# County of Fairfax, Virginia

## STAFF REPORT ADDENDUM

### SPECIAL PERMIT AMENDMENT APPLICATION NO. SPA 81-A-022-9 CALVARY MEMORIAL PARK, INC. T/A FAIRFAX MEMORIAL PARK AND FAIRFAX MEMORIAL FUNERAL HOME, L.L.C.

**EXHIBIT A**  
 PRELIMINARY LAYOUT PLAN  
**FAIRFAX MEMORIAL PARK**  
 FAIRFAX COUNTY, VIRGINIA

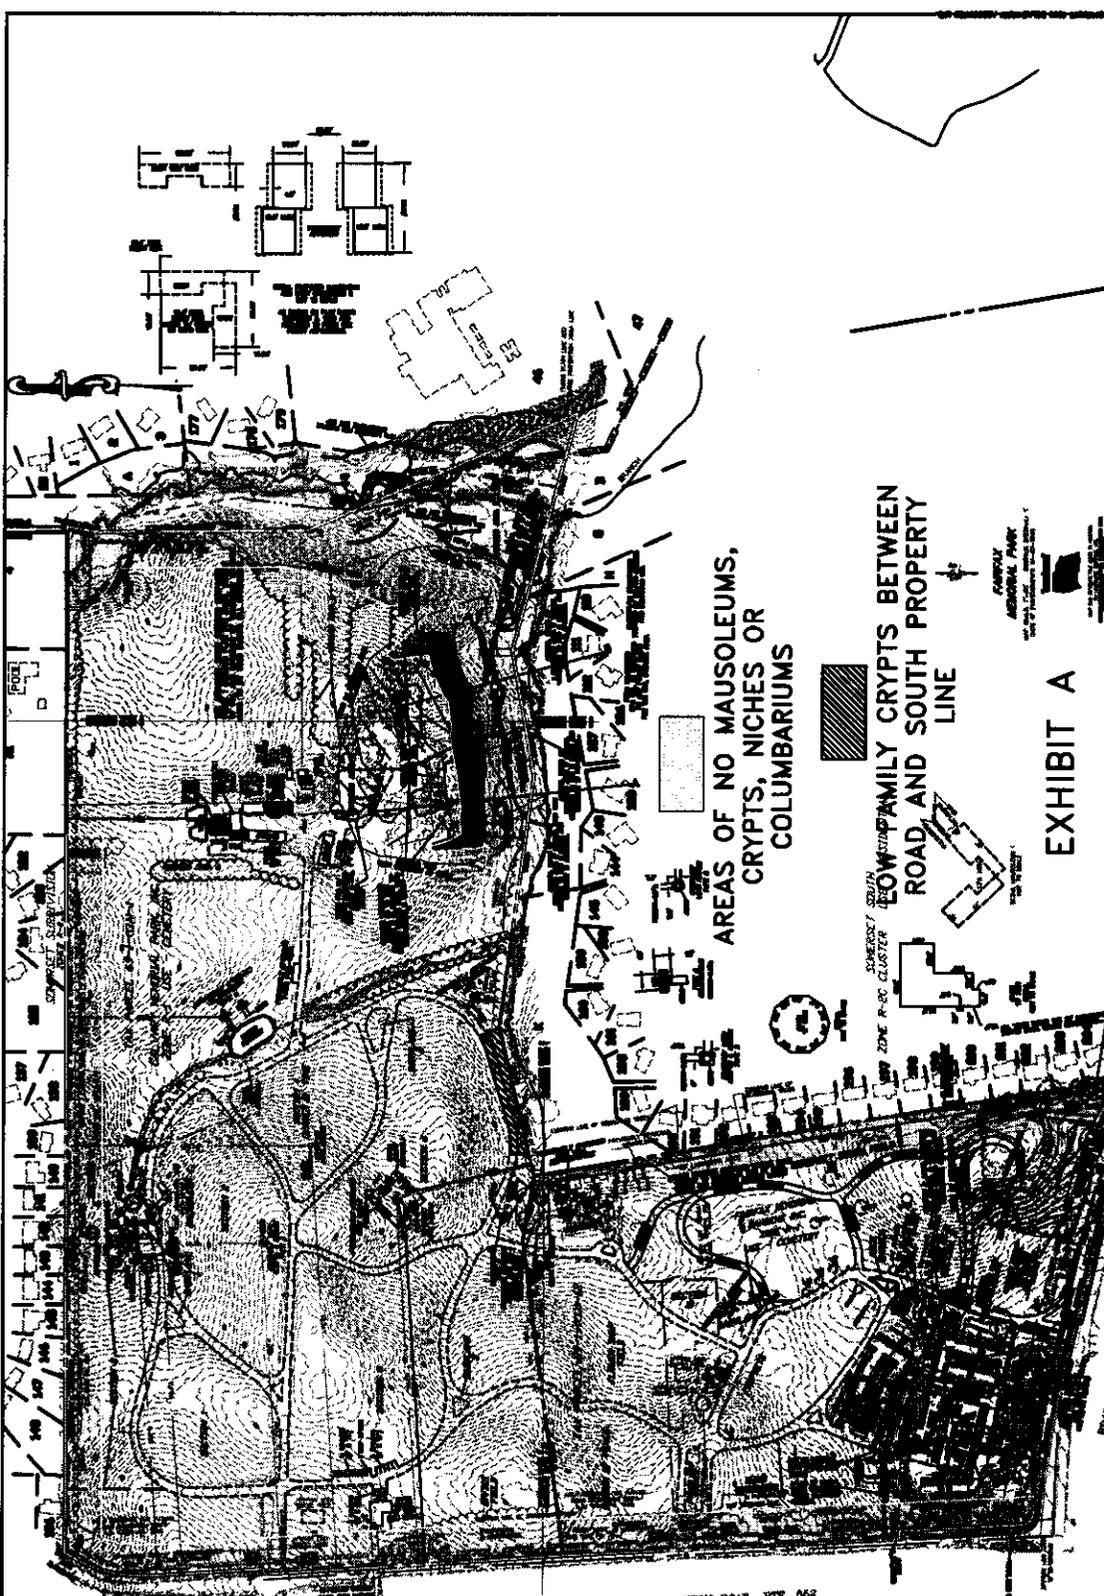
recommended a distance of at least 100 feet to ensure that residential properties will not be affected visually by the potential placement of these structures. On the revised SPA plat, Sheet 5 depicts areas of shading extending between 100 and 300 feet from the majority of the exterior property lines where the applicants have agreed not to place these structures. The applicants will continue to be required to provide additional screening, and the structures are limited to a maximum height of 25 feet and a maximum area of 400 square feet in size. The exceptions to this 100 foot setback are along a portion of the northern property line adjacent to a community pool and along the mid-southeastern property line where structures have previously been approved. Staff also did not originally support these structures on top of the finished soil storage area. However, as now proposed, with the detention ponds and face of slope, the closest any structure could be located on the stockpile is 300 feet from a residential property. Staff believes with the distance proposed, the planting which will be required on the face of the slope and the existing vegetation in the RPA/EQC, that the location will not be detrimental to residential properties.

- No structures shall be located on top of occupied gravesites;
  - No structures shall be located within the shaded areas as depicted on Sheet 5 of 7, Exhibit A, of the SPA plat;

PROPOSED GRADING (PHASE I)  
 SEE DETAIL SOUTH OF INTERSECTION BELLEVILLE  
 FAIRFAX MEMORIAL PARK  
 FAIRFAX COUNTY, VIRGINIA

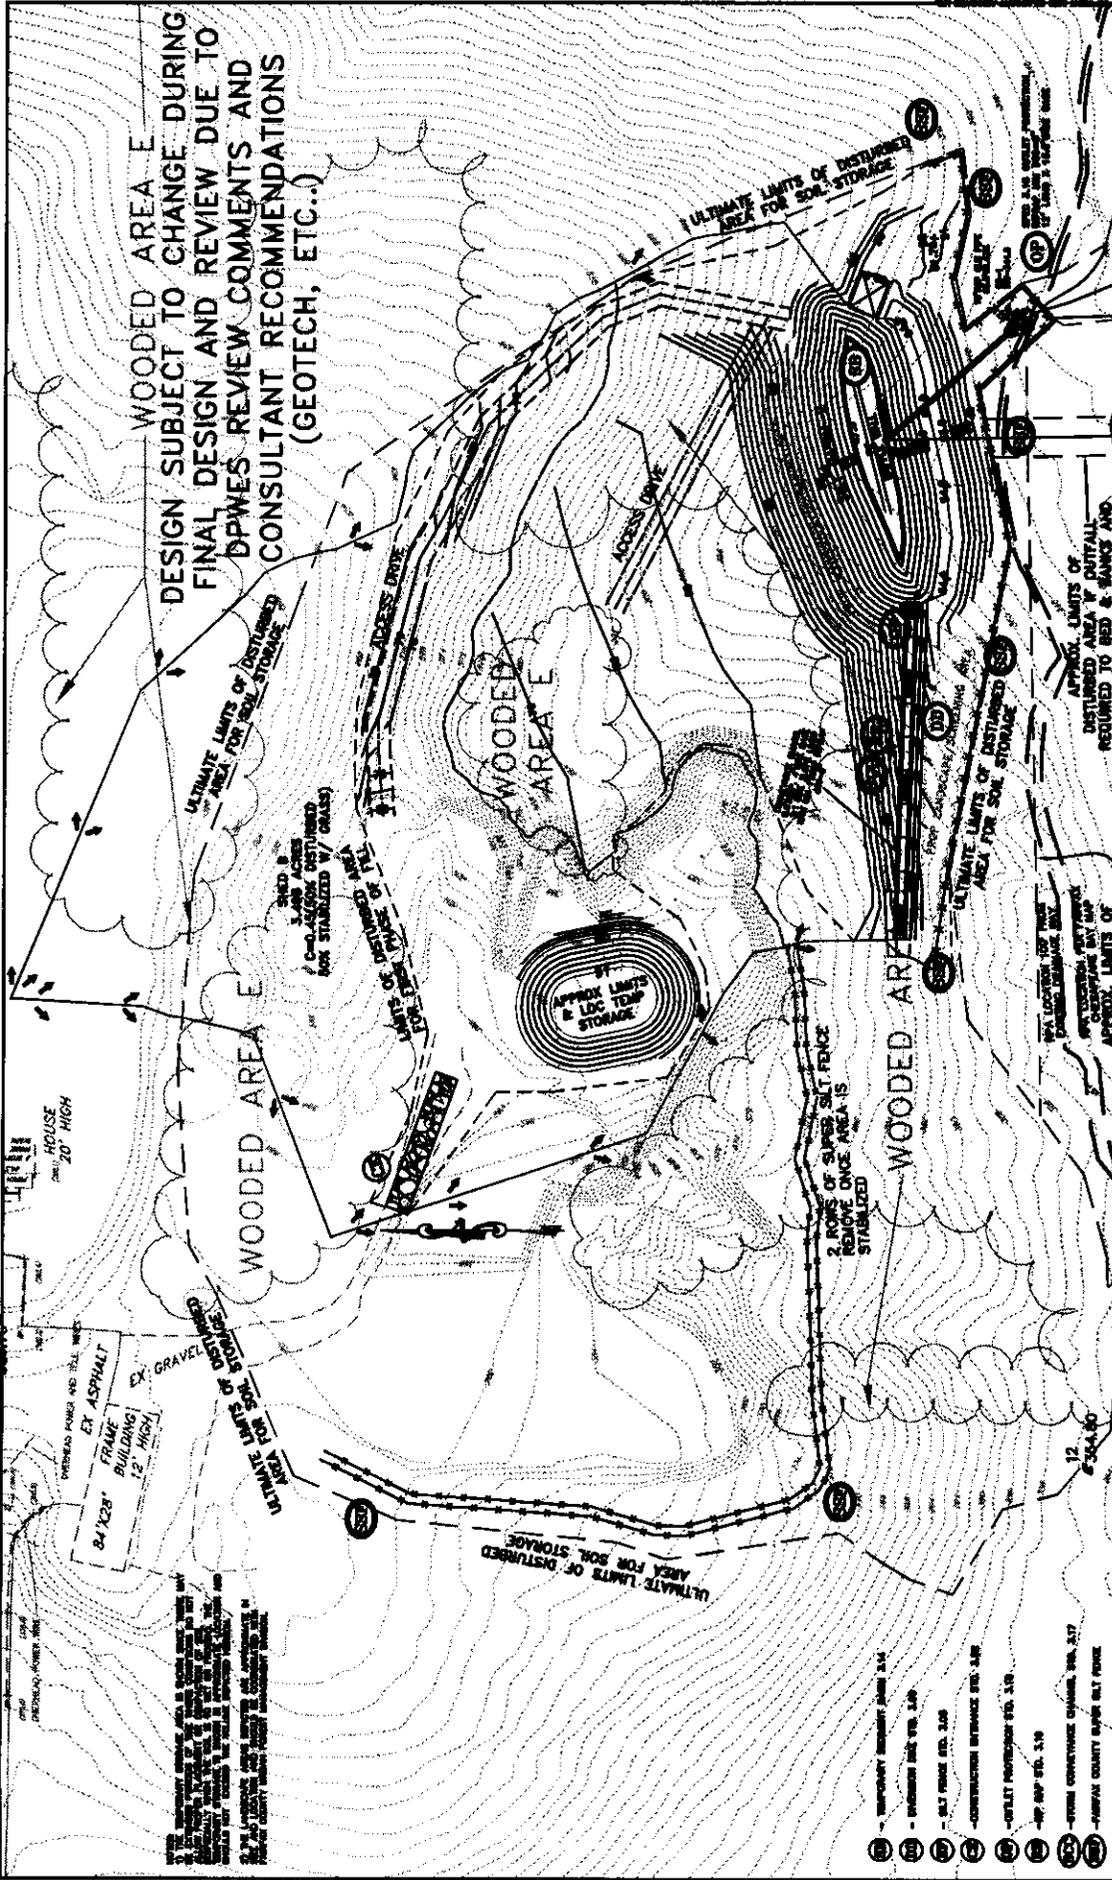
The development conditions have been revised to limit the maximum area and height of soil storage. Additionally, Sheets 6 and 7 depict phase 1 of the fill, which will be submitted under the first site plan submission.

EXISTING VEGETATION MAP  
**FAIRFAX MEMORIAL PARK**  
 FAIRFAX COUNTY, VIRGINIA

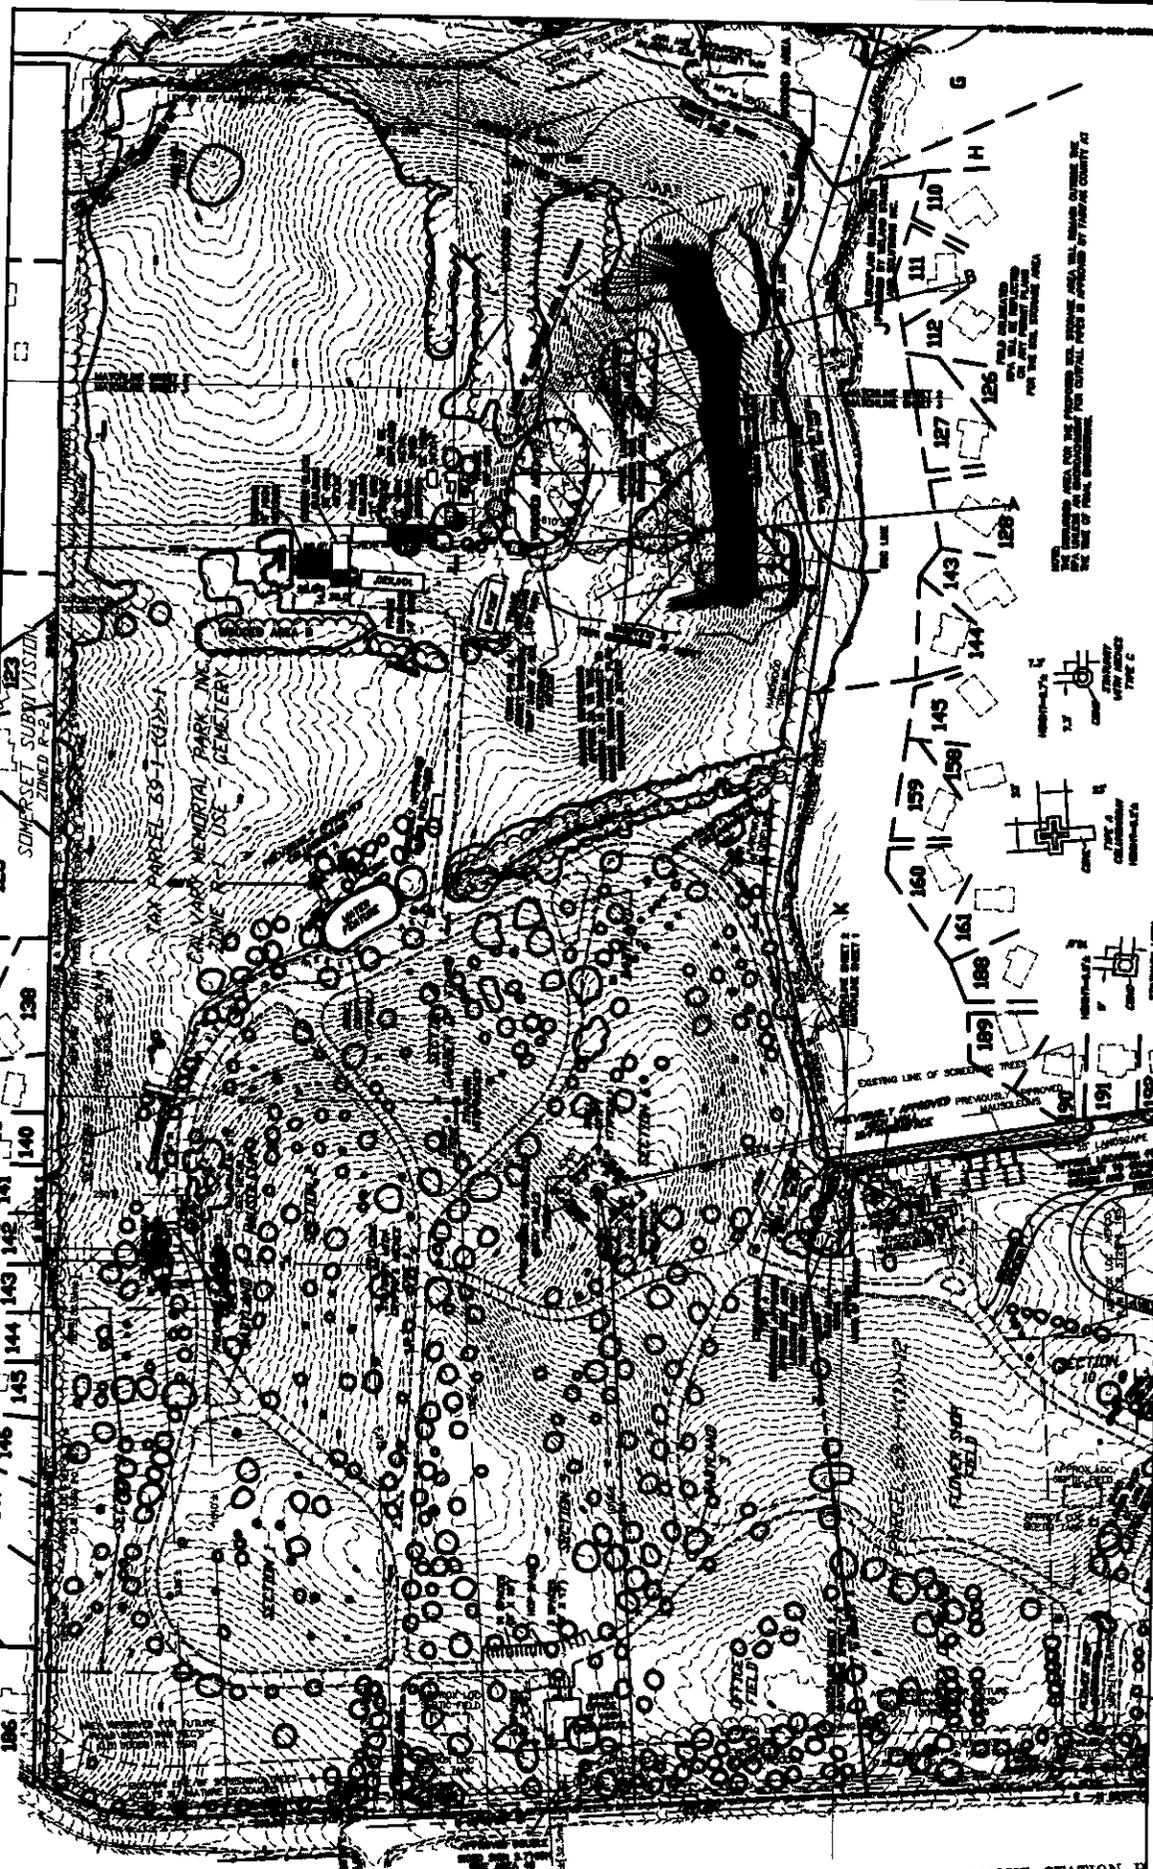
7. **Comment:** The Existing Vegetation Map includes a narrative request for a Tree Preservation Target Deviation. It is unclear if this request is for the duration of the SPA and who the request is addressed to. We therefore recommend that a development condition be included to address this issue.

**Recommendation:** UFMD recommends adding a development condition addressing the Tree Preservation Target Deviation request during each phase of the site plan submission as follows: “During the site plan review process a Tree Preservation Target Deviation request shall be submitted for review and approval by the Urban Forest Management Division. This deviation request shall be based on PFM 12-0507.3A and its applicable conditions and all other PFM requirements as may apply at time of site plan submission”.
